UNITED STATES PATENT AND TRADEMARK OFFICE

APPLICATION NO.	FILING DATE	FIRST NAMED INVENTOR	ATTORNEY DOCKET NO.	CONFIRMATION NO.
10/586,723	07/17/2006	William M. Heyn	WHP-P1-PCT	8712

Office Action Summary	Application No. 10/586,723	Applicant(s) HEYN, WILLIAM M.	
	Examiner DEBRA M. SULLIVAN	Art Unit 3725

DETAILED ACTION***Drawings***

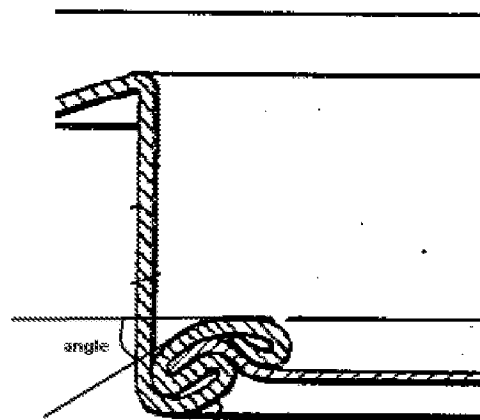
1. Claims 1-7 are rejected under 35 U.S.C. 103(a) as being unpatentable over Hirsch et al (US 1,866,469) in view of Admitted Prior Art. In reference to claim 1, as best understood, Hirsch et al discloses a method for applying an end panel (14) to a closure ring (2) for a container (1) wherein the closure ring (2) includes an inwardly directed annular flange portion (13) having a

In reference to claims 2 and 3, Hirsch et al further discloses the angle to be within a range between 5 and 45 degrees and approximately 25 degrees, as seen in figures 2 and 9. It is further noted that Applicant has failed to provide any criticality for the specified angle and the importance or problem it overcomes [See pg. 3 line 32 – pg. 4 line 1].
